Minutes
of
58th PCC meeting

MINUTES OF 58TH PROTECTION SUB-COMMITTEE MEETING HELD AT ERPC, KOLKATA ON 29.08.2017 (TUESDAY) AT 11:00 HOURS

ITEM NO. B.2: Disturbance at 400 kV Bokaro S/s on 13-07-17 at 20:18 hrs

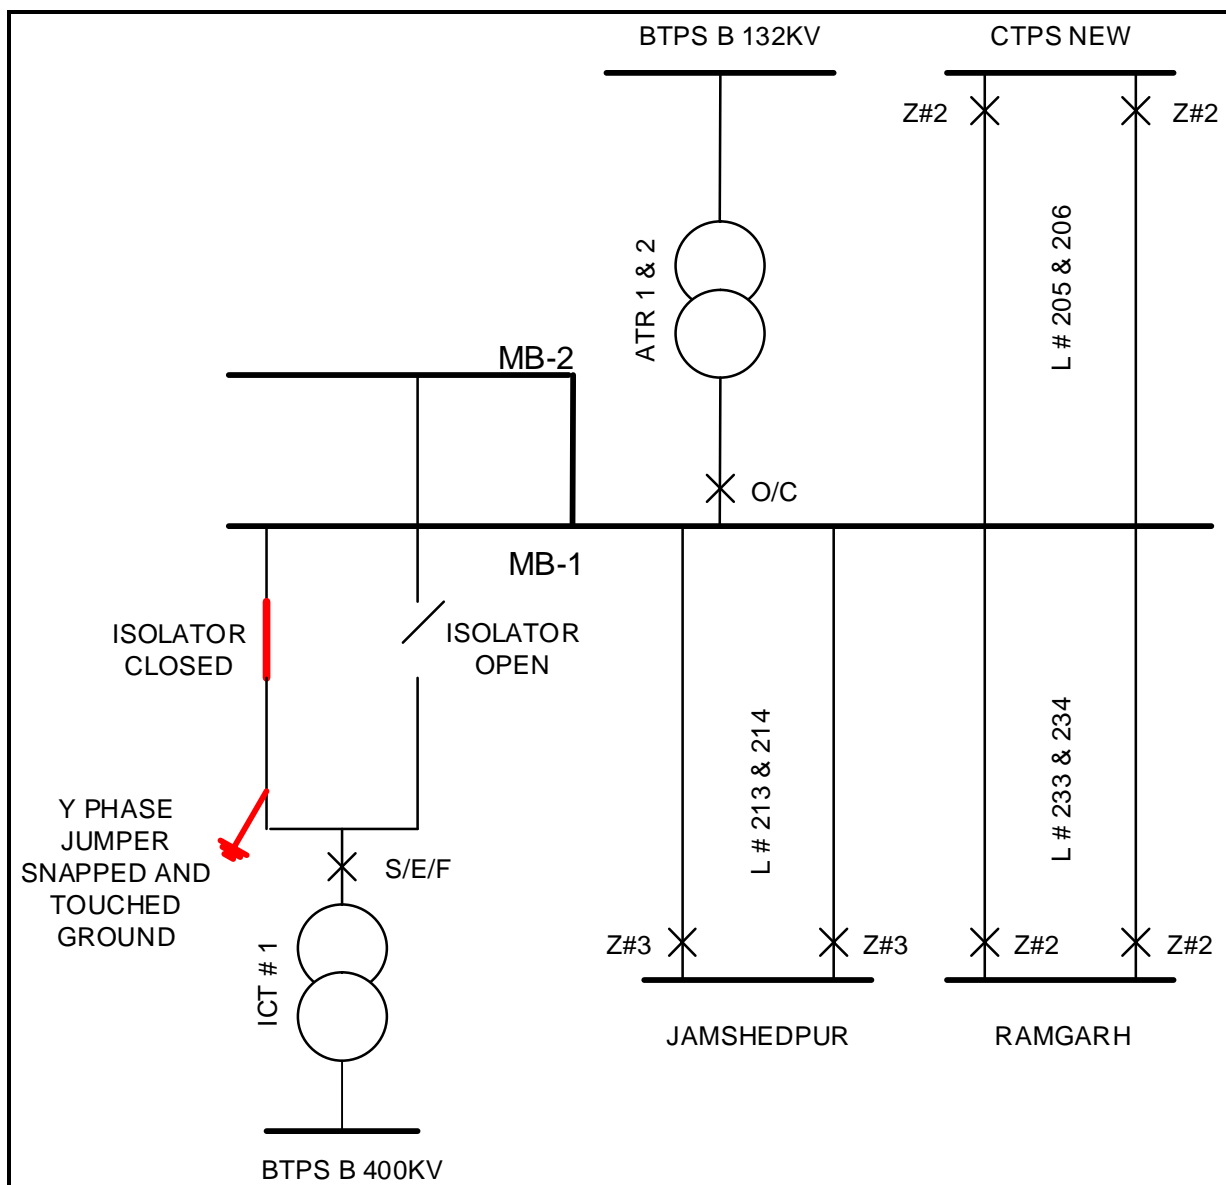
1. As Bus-Differential protection circuit and relays were found to be healthy during subsequent testing, it is apprehended that due to wrong selection of VAJC Relays in multiple bays, CT supervision relay (95A & 95AX) of Main Zone # 1 was in operated condition at the time of fault which remained unnoticed (while testing 95A relay it was also observed that annunciation did not appear when the relay was operating), which resulted in bypassing of Main Zone#1 Bus-differential protection function at the time of the fault. Thus the fault could not be cleared through Bus-differential protection even though Check Zone relay had operated.
2. The tripping of L # 203, 204, 233 & 234 through Distance Zone 2 from remote end is correct. The tripping of L # 213 & 214 from remote end through Distance Zone 3 might have happened due to

overreach due to mutual coupling as this line is a long(150km) line. The Zone 2 settings of the line was already 150% of line length and it is felt that it would not be prudent to increase the Z2 reach further. Hence no remedial measure has been taken for this Zone 3 tripping.

DVC explained that old Electro Mechanical type bus bar protection was available at 220kV Bokaro S/s. The CT supervision relay (95A & 95AX) of Main Zone # 1 might be in operated condition at the time of fault which remained unnoticed as the annunciation did not appear. This resulted in bypassing of Main Zone#1 Bus-differential protection function at the time of the fault. Thus the fault could not be cleared through Bus-differential protection even though Check Zone relay had operated.

1. Annunciation Ckt of 95A relay was checked and problem was resolved.
2. On both days CRITL visited BTPS B for busbar protection testing it has been observed that VAJC Relay operations are not as per Isolator positions. As wrong VAJC operation may ultimately lead to mal operation/non operation of Bus Differential protection it is strongly recommended to check VAJC position after each Isolator operation.

3. A complete refurbish of Bus Differential Scheme with Numerical Relays is strongly recommended. As in the present scheme, The CT Switching Relays (VAJC Relays) are situated at switch yard and the flag operation of the Relay cannot be observed by the operators unless going to the S/Y after each Isolator operation. Moreover, the wire schedules for operation of VAJC Relays through relevant Isolator contacts are also not available at BTPS-B which makes it more difficult for maintenance of the scheme.

PCC advised DVC to replace these old Electro Mechanical bus bar protection with numerical bus bar protection to improve the reliability.

ITEM NO. B.3: Disturbance at 400kV Patna on 03-07-17 at 18:53 hrs.

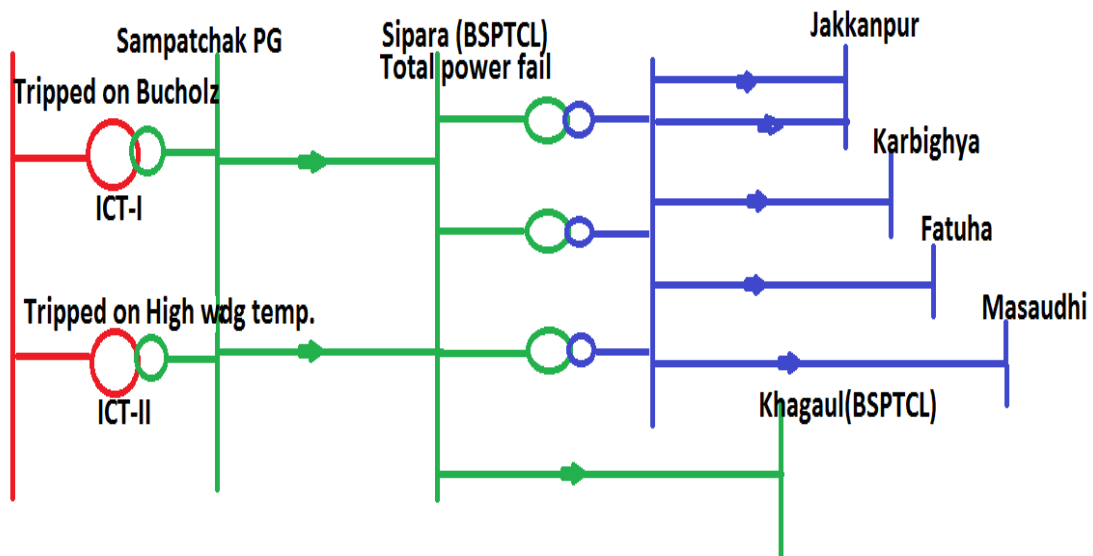
Powergrid explained that 400/220 kV 500 MVA ICT - I at Patna tripped on operation of Buchholz relay due to ingress of moisture through cables during rain.

Powergrid added that the cable connections of buchholz relay are connected from top of the relay for all old transformers. This is causing moisture ingress through cable connections during rain.

Powergrid informed that they will place a shed on top of bucholtz relay to stop the moisture ingress.

ITEM NO. B.4: Disturbance at 220 kV Lalmatia S/s on 15-07-17 at 09:40 hrs & 13:54 hrs

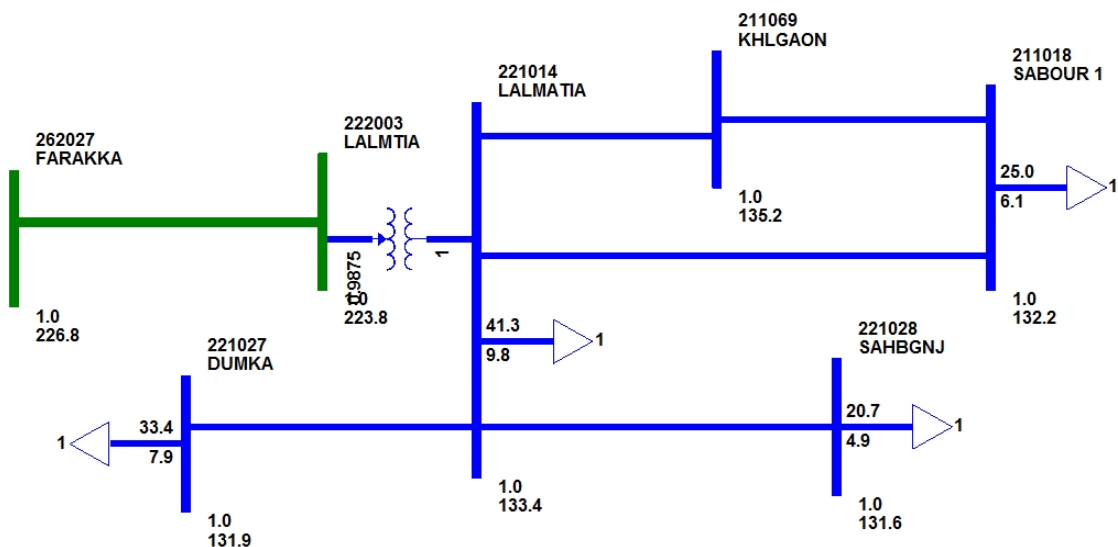
132 kV Kahalgaon(BSPTCL) - Lalmatia S/C line tripped from both ends on B-ph O/C, E/F protection simultaneously 132 kV Kahalgaon(NTPC) - Lalmatia S/C line tripped from Lalmatia end only on O/C, E/F protection. NTPC informed that 132 kV Kahalgaon(NTPC) - Lalmatia S/C line did not trip from Kahalgaon(NTPC) end.

132 kV Kahalgaon(BSPTCL) - Lalmatia S/C line tripped from Lalmatia end on O/C, E/F protection simultaneously 132 kV Kahalgaon(NTPC) - Lalmatia S/C line tripped from Lalmatia end only on O/C, E/F protection. NTPC informed that 132 kV Kahalgaon(NTPC) - Lalmatia S/C line did not trip from Kahalgaon(NTPC) end.

PCC advised JUSNL to review the O/C, E/F protection settings of 132 kV Kahalgaon(NTPC) - Lalmatia S/C line at Lalmatia end as the line got tripped from Lalmatia end only in both the cases.

ITEM NO. C.1: Disturbance at 220 kV Lalmatia S/s(JUSNL) on 21-05-17 at 16:39 hrs.

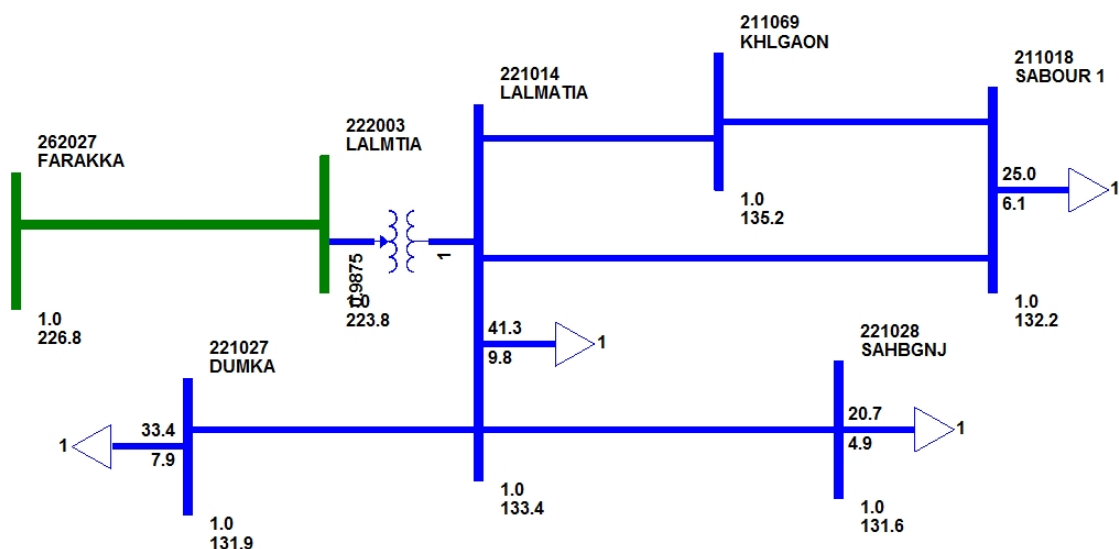
In 56th PCC, NTPC informed that 220kV Farakka-Lalmatia line tripped from Farakka end on B-N fault, the fault distance was 59 km. 132 KV Lalmatia- Kahalgaon line didn't trip from Kahalgaon end. However DR recorded in relay of this line indicates that aforesaid line tripped at Lalmatia end.

PCC advised NTPC to collect tripping details of 220kV Farakka-Lalmatia line at Lalmatia end also and submit to ERLDC and ERPC.

Annexure-B6

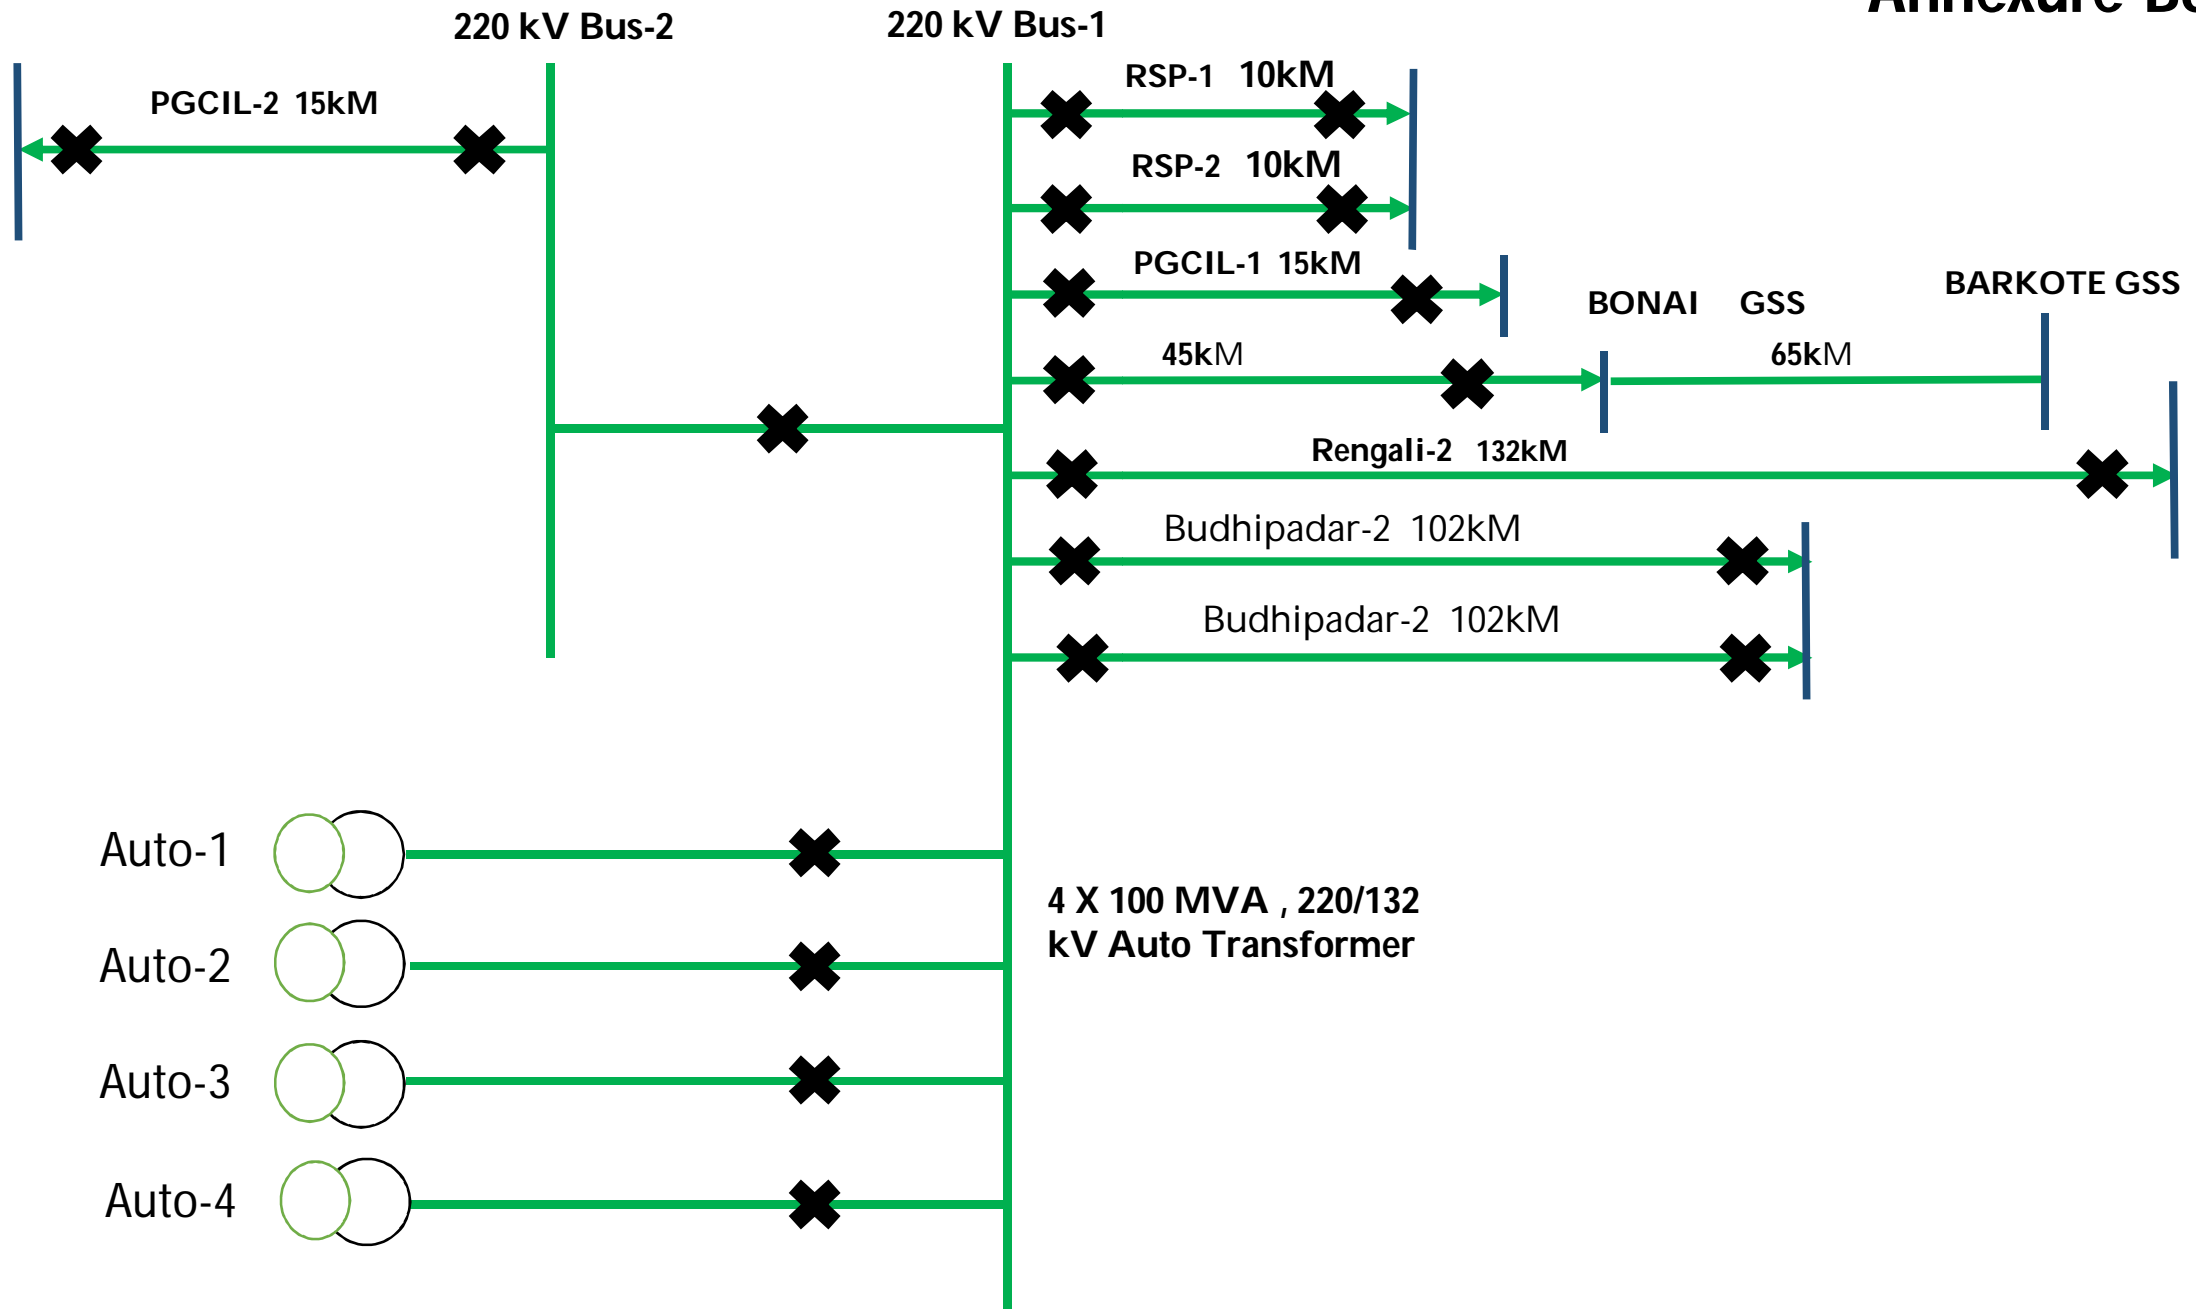
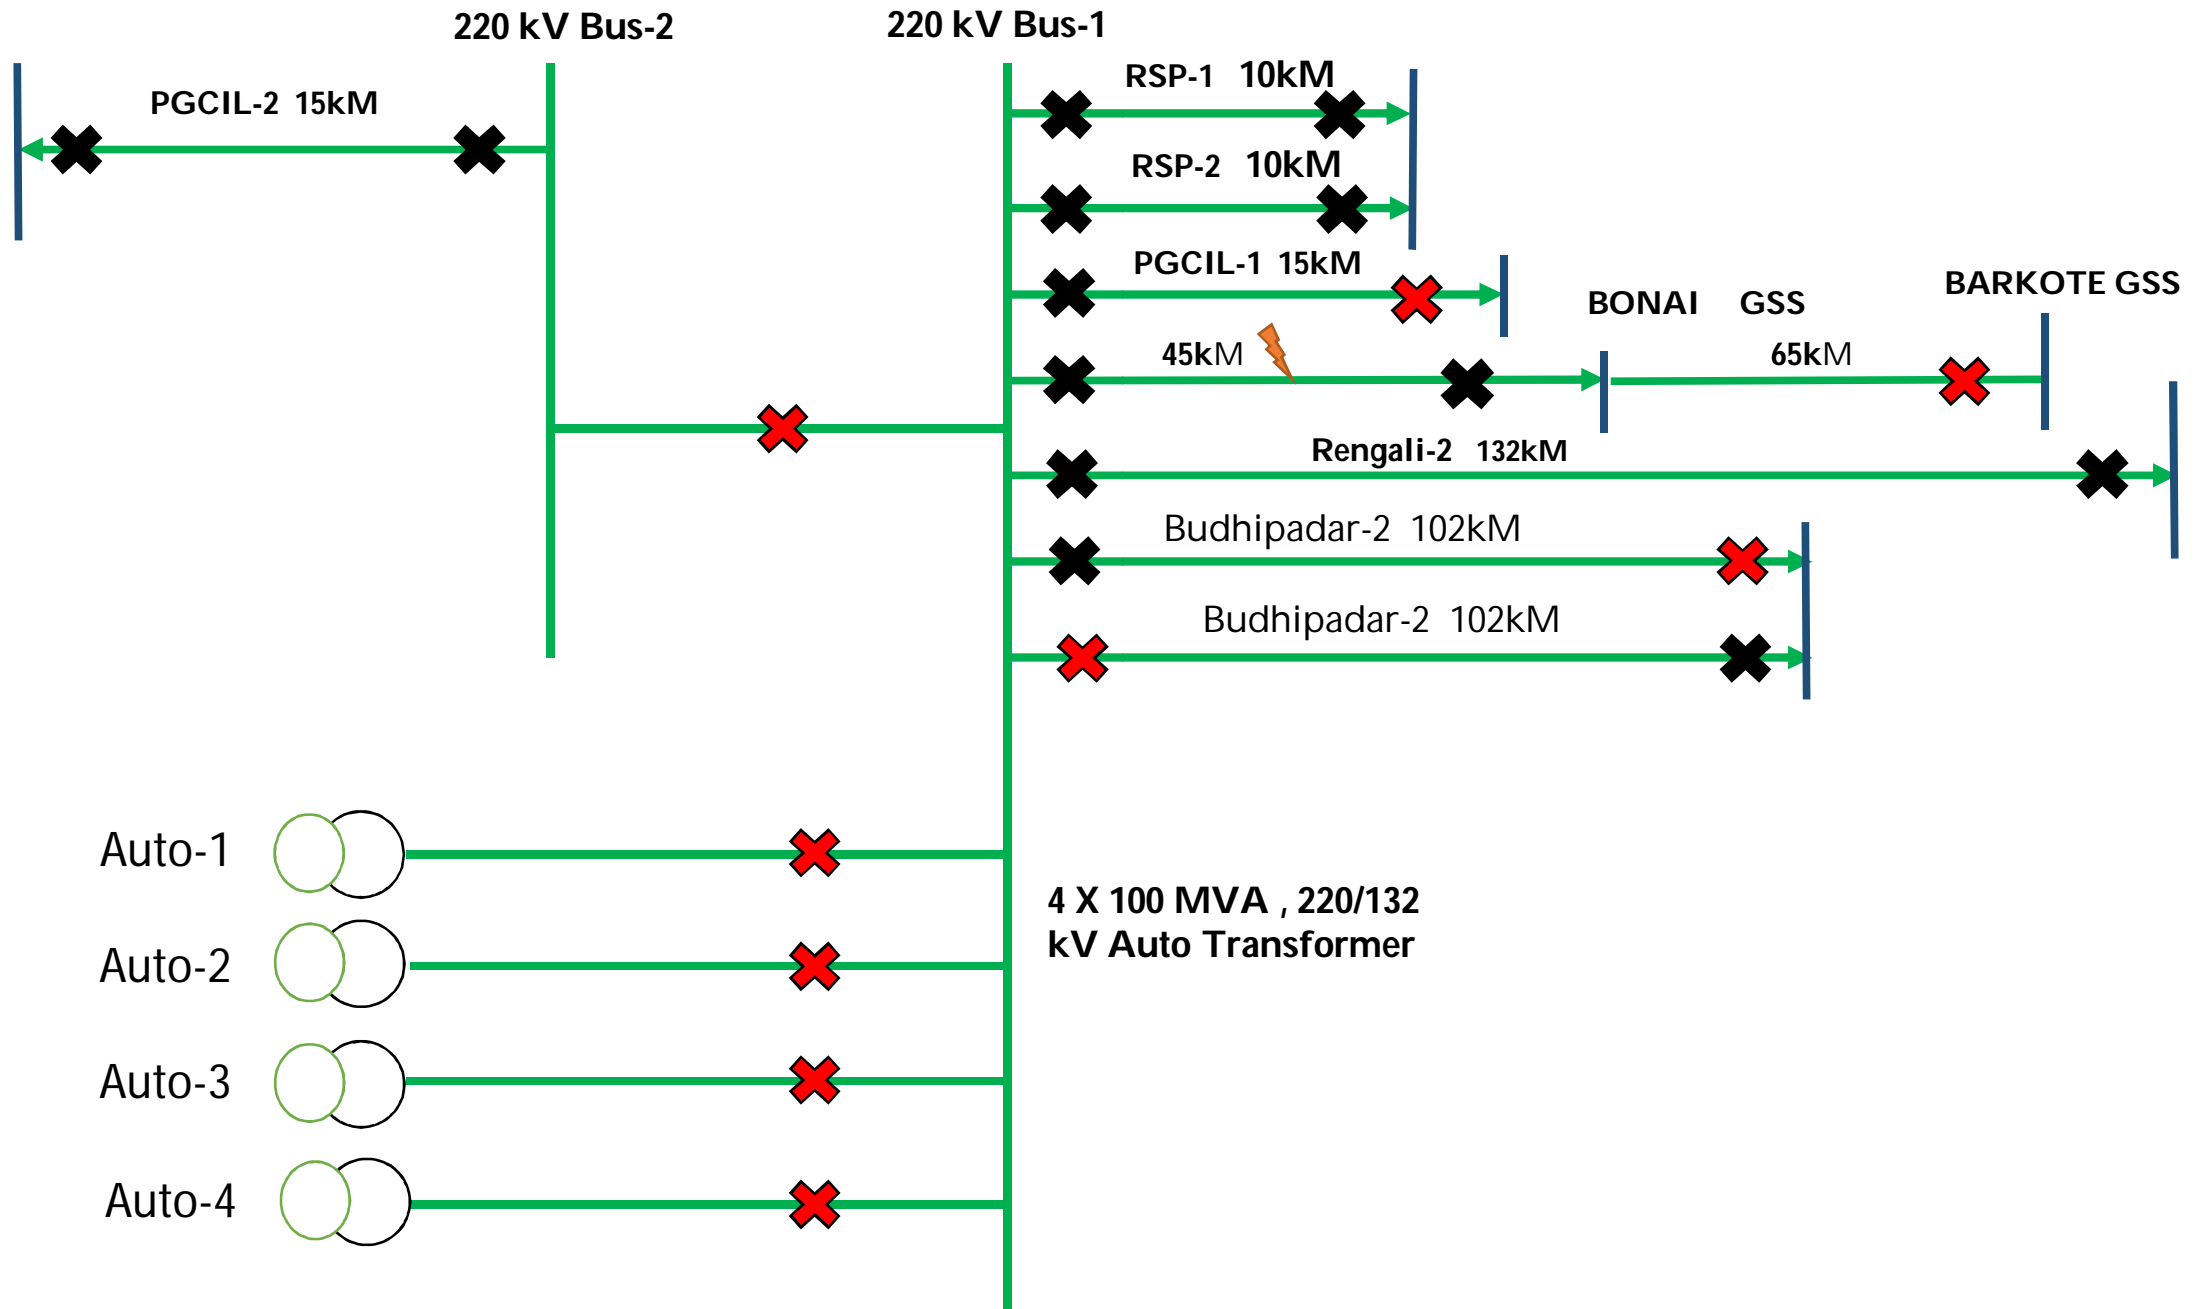
- At 11:24 hrs, B phase isolator drop jumper of 220 kV Tarkera - Chandiposh - Rengali snapped at Tarkera end.*

- Relay at Tarkera end failed to operate due to some connection problem in DC cable.
- As a result, 220kV Tarkera-Bonai-Barkote tripped from Barkote end
- 220kV Tarkera-Rengali line-I tripped from Rengali end
- 220 kV Tarkera-Rengali line II which was charged through bus coupler got tripped at Tarkera end on operation of back up relay.
- 220 kV Tarkera-Budhipadar-2 feeder tripped at Budhipadar end on Zone 3.
- Budipadar end relay of 220kV Tarkera-Budipadar line-I operated but did not issue trip command to CB because of some connection problem. The same tripped from Tarkera end on reverse zone
- The 220 kV side of 220/132kV Auto transformer 1,2,3 and 4 tripped on operation of back up relay.

PCC felt that 220kV Tarkera-Bonai line should trip from Bonai end.

OPTCL added that they have replaced the DC cable of Tarkera end relay of 220 kV Tarkera - Chandiposh – Rengali line. Cables between relay to CB of Budipadar end of 220kV Tarkera-Budipadar line-I have been replaced. Bonai end relay settings of 220kV Tarkera-Bonai line have been reviewed.
